**RE:** Inspection conducted on September 21, 2022

**AFIN 03-00051**

Permit Number 0249-S1-R2

## Office of Land Resources Regulated Waste Operations Class 1 Landfill Inspection Form

Location	NABORS Class 1				Permit	0249-S1-R2	AFIN	03-00051	
Photographer Darrell Norton, Inspector				ΣW	Witness	Mason Goheen			
Photo #	6	Of	6			Date	9/21/2022	Time	1124

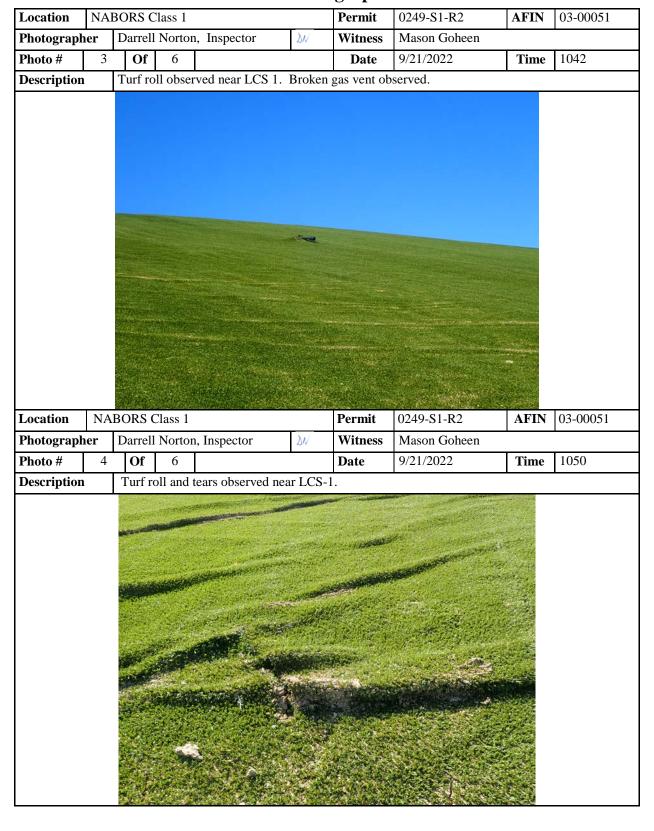
**Description** Turf roll observed near LCS-6, with woody vegetation present.
